General Electric Company  
175 Curtin Avenue, San Jose, CA 95125

Chet Poslusny, Senior Project Manager  
Standardization Project Directorate  
Associate Directorate for Advanced Reactors  
and License Renewal  
Office of the Nuclear Reactor Regulation

Subject: Submittal Supporting Accelerated ABWR Review Schedule - **DFSER Chapter 8 Responses**

DFSER CHAPTER 8 ISSUES & GE RESPONSES  
.DO FSESTAT .REPORT FORM FCRMemo

Figure 8.3-1  
(Sheet 3 of 3)

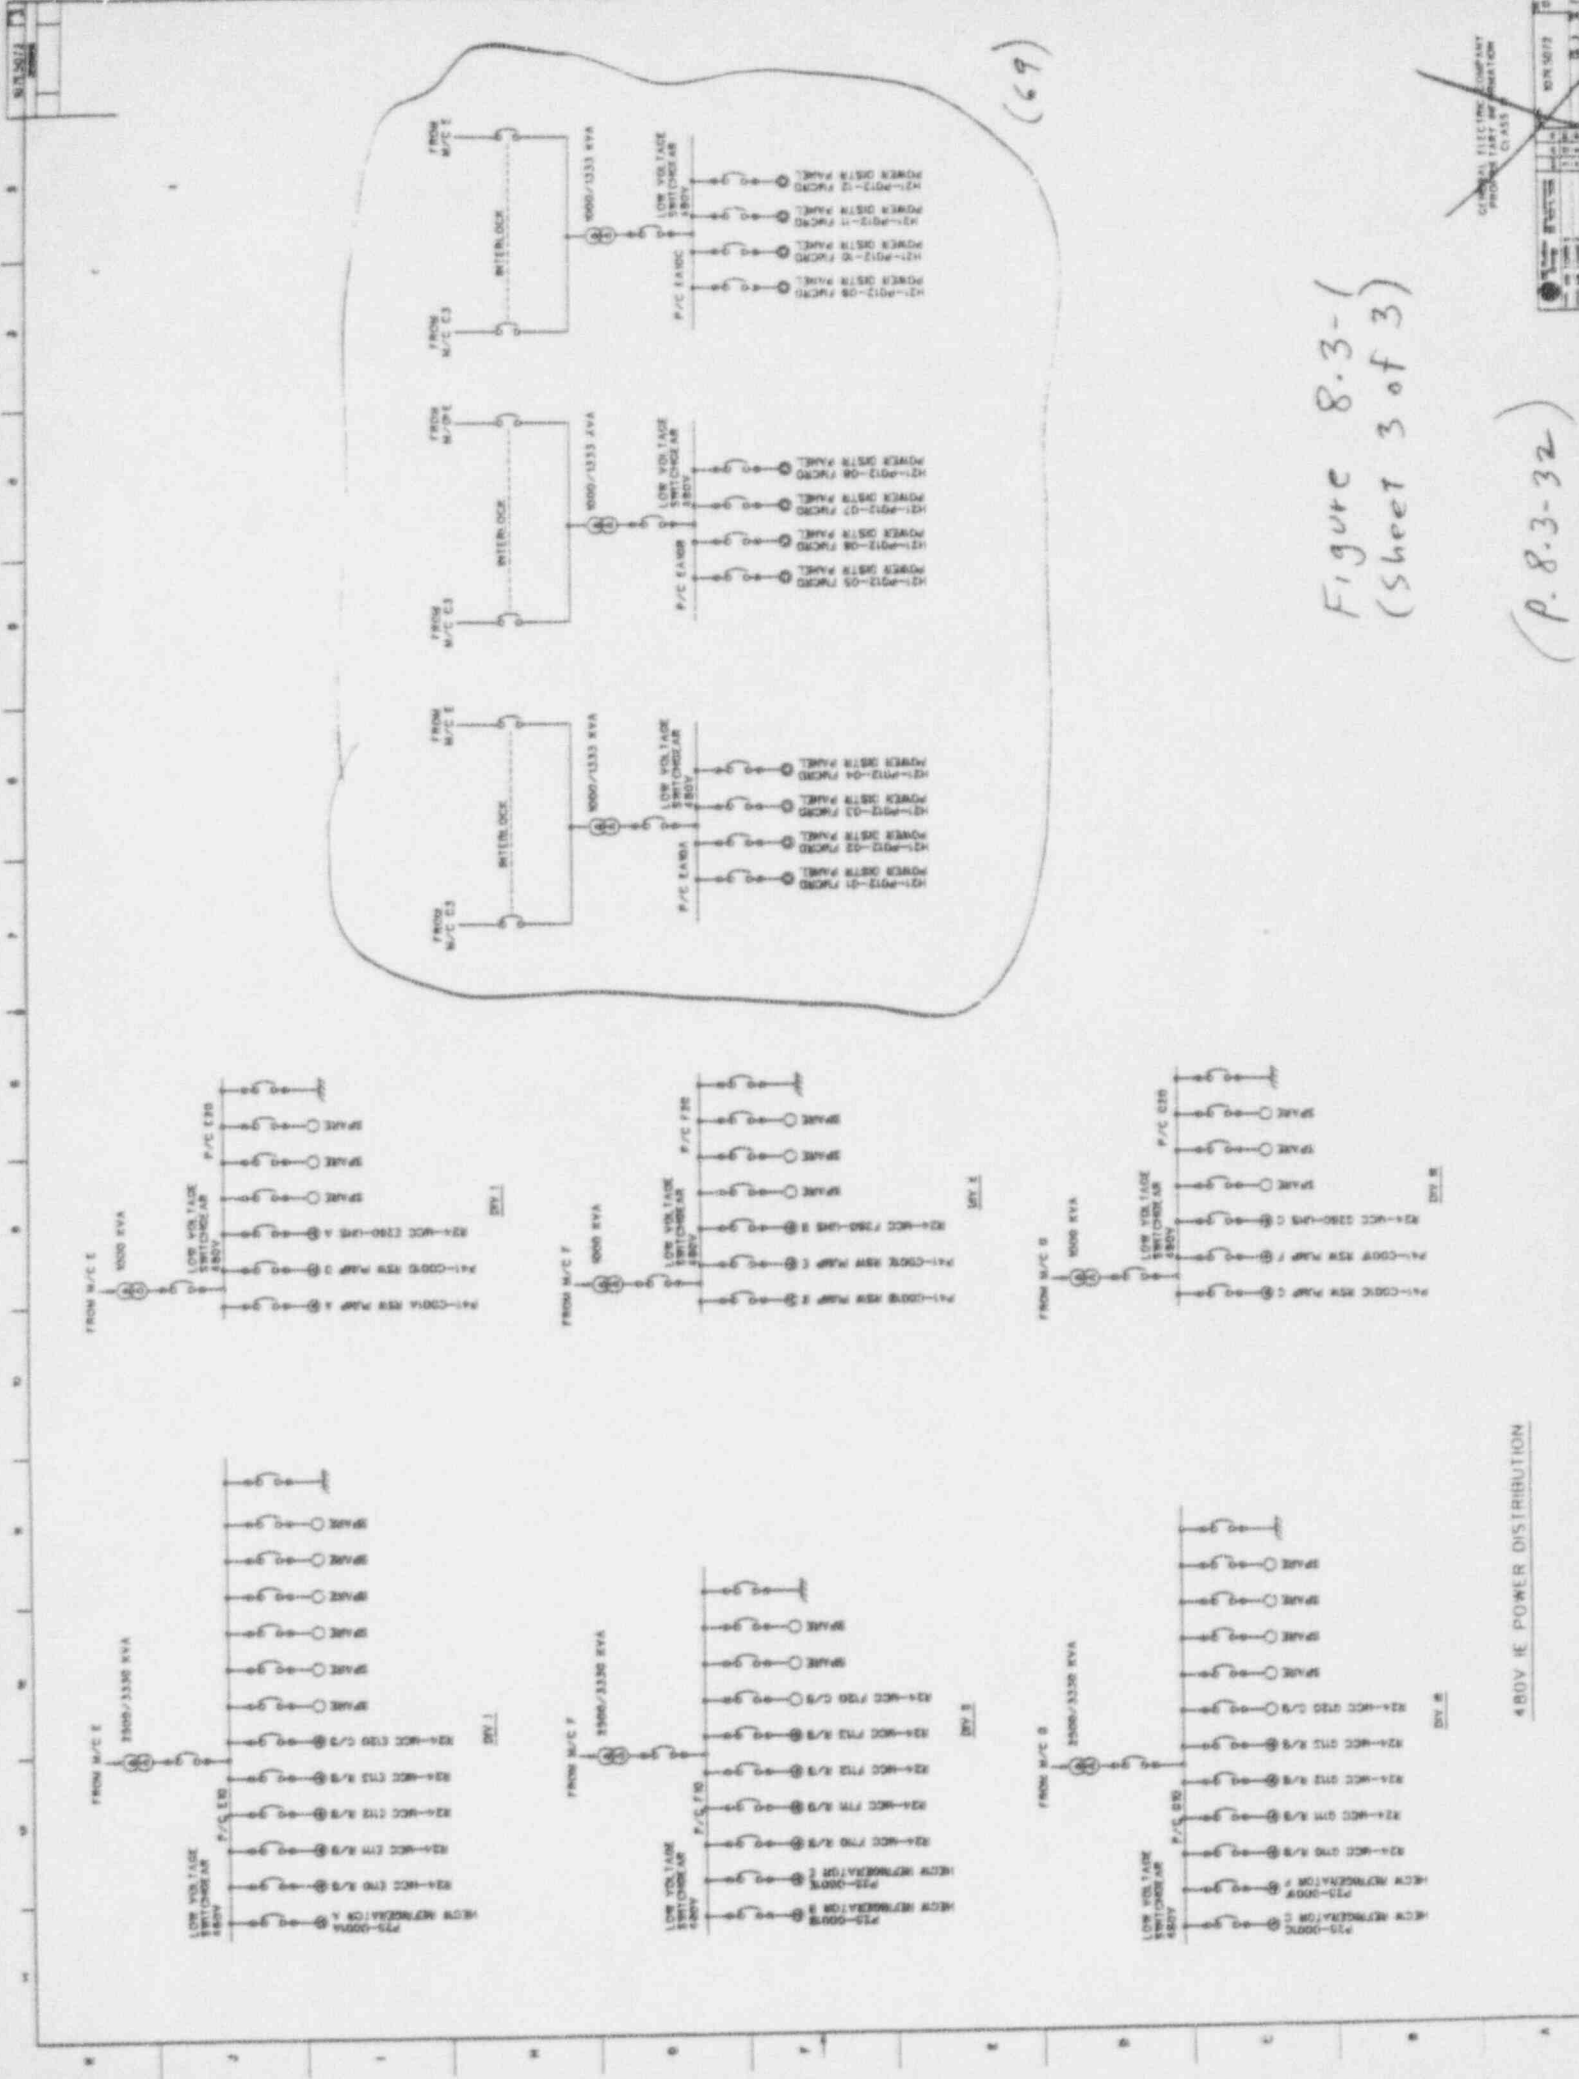
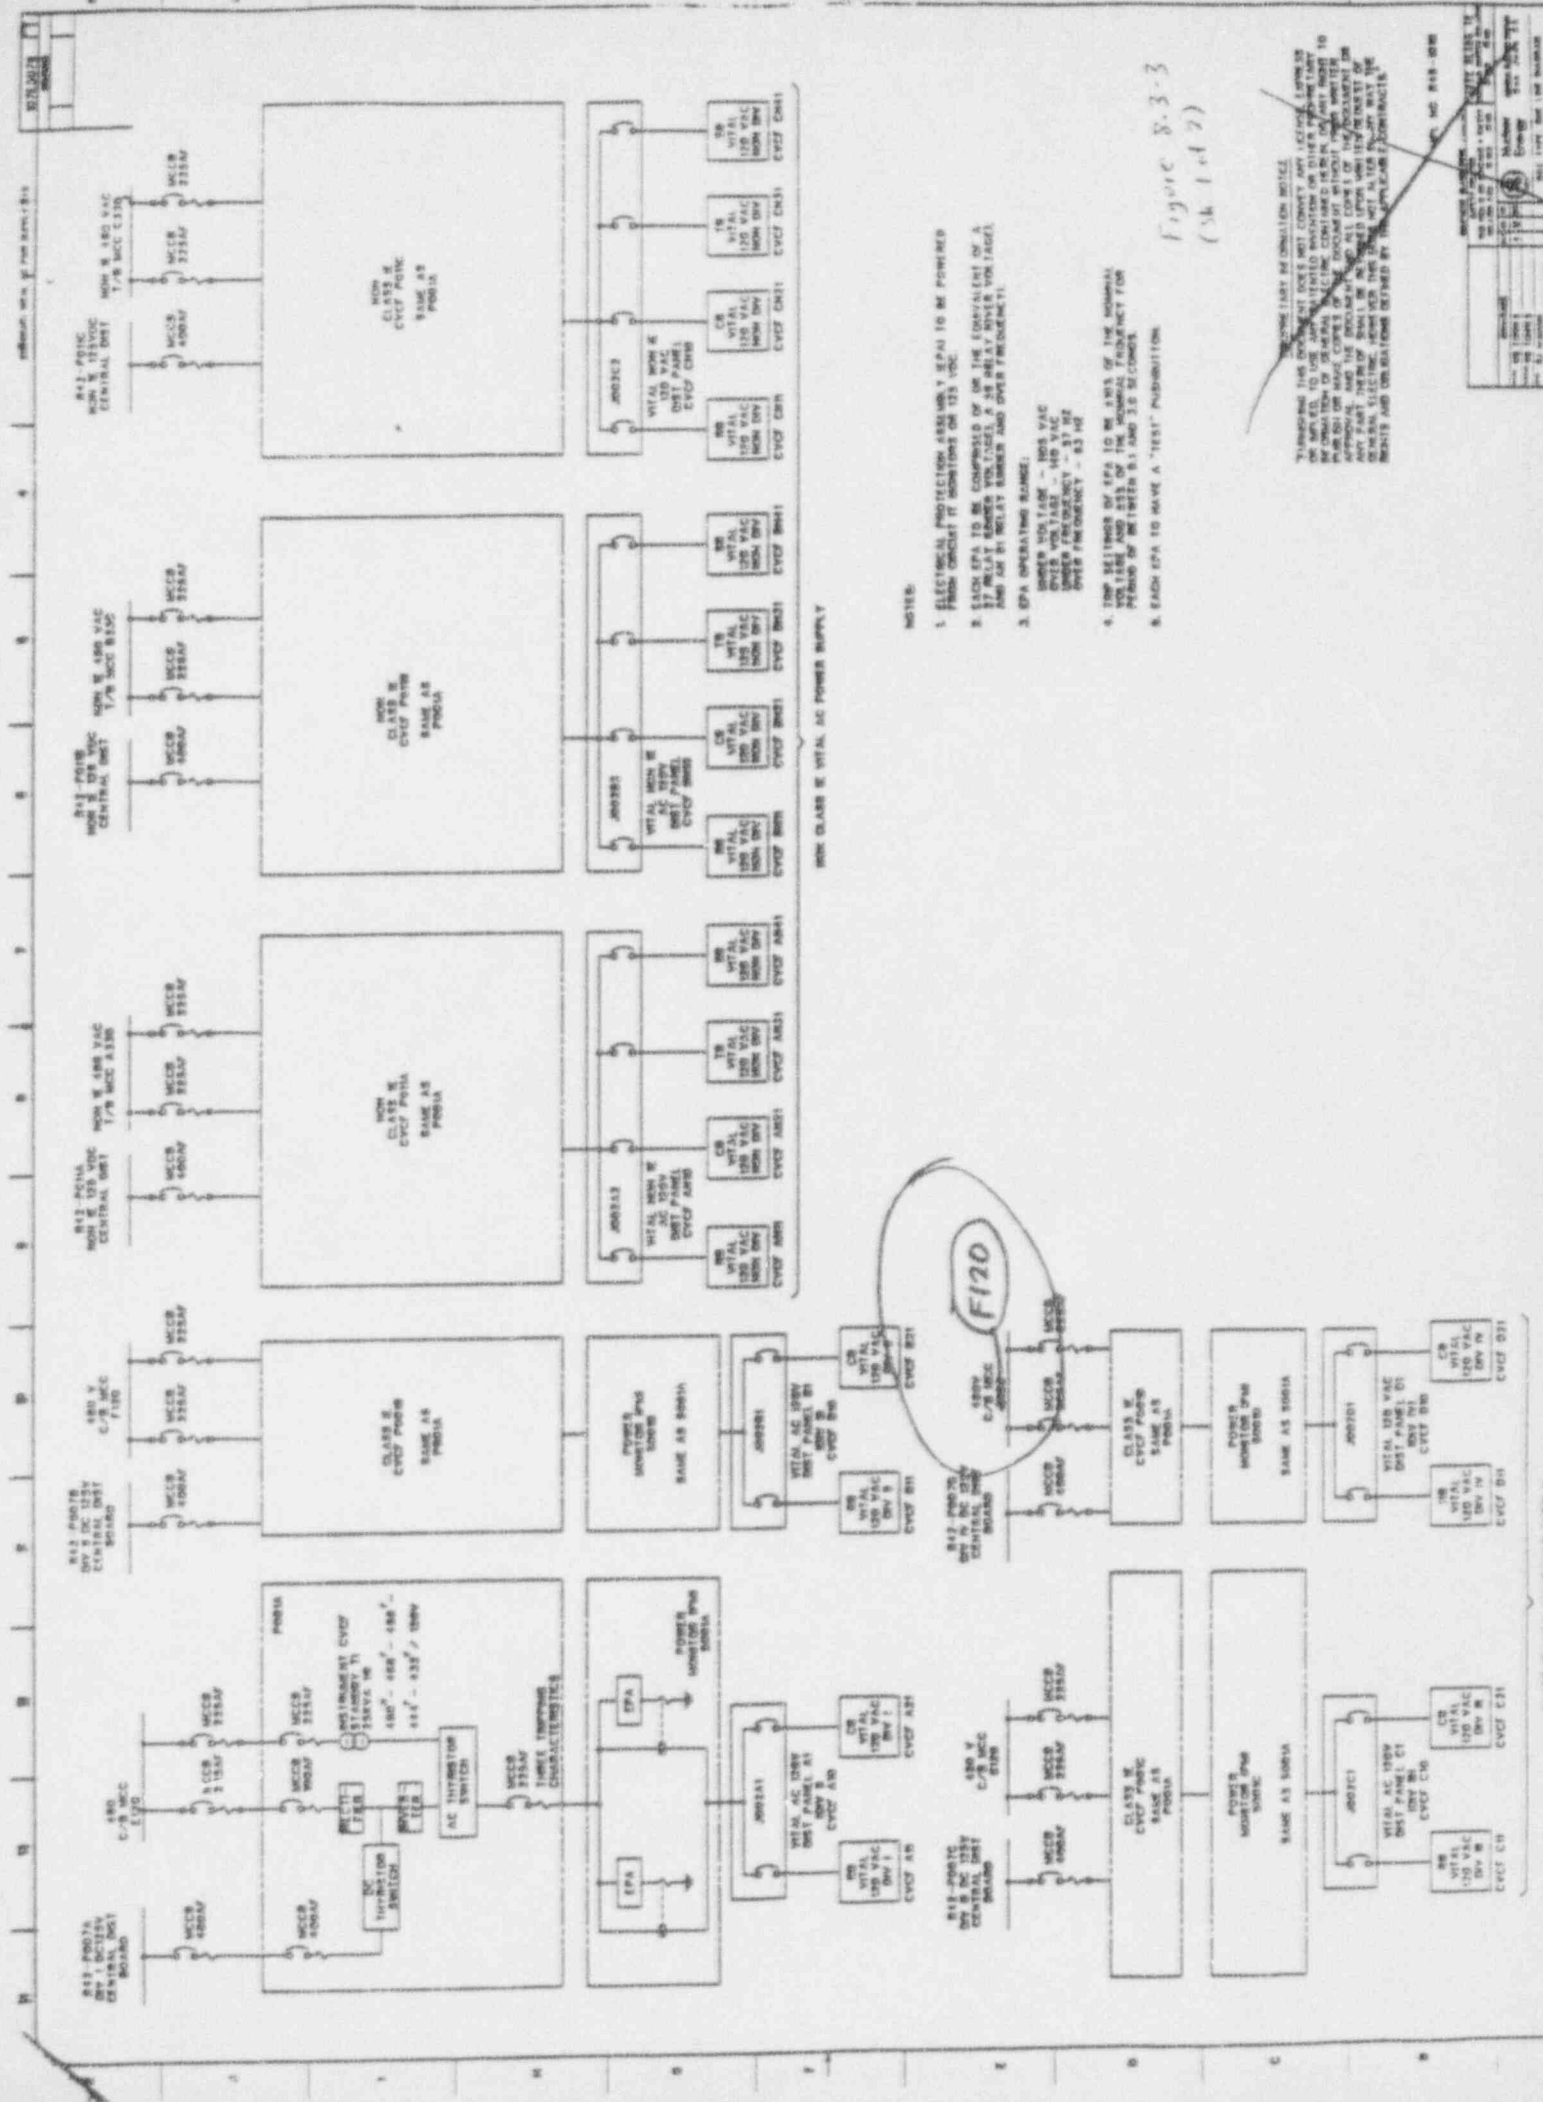
8.3-1	CONF	33	Although considered closed per the February meetings, the staff made a subsequent phone call (3-23-93) to request the transfer switches identified in 8.3.1.1.1, page 8.3-3, be designated as "Class 1E Associated" per our February meeting agreements.	GE responded during the call, that this was being done already in association with the March markup submittal. The specific addition was made in association with DFSER confirmatory item 8.3.3.6-1 (Ref. 69 CONF). The last paragraph on page 8.3-3 has been modified as follows:
				"Power is supplied to each FMCRD load group from either the Division 1 Class 1E bus or the non-Class 1E PIP bus through a pair of interlocked transfer switches located between the power sources and the 6.9 kV/480V transformer feeding the FMCRD MCC. These transfer switches are classified as Class 1E associated, and are treated as Class 1E."
				For clarification, the following sentence was added at the end of the third-to-last paragraph of 8.3.3.6-1 (top of page 8.3-4):

"The design minimizes the probability of a single failure affecting more than one FMCRD group by providing three independent Class 1E feeds (one for each group) directly from the diesel generator backed 6.9 kV bus (see sheet 3 of Figure 8.3-1)."
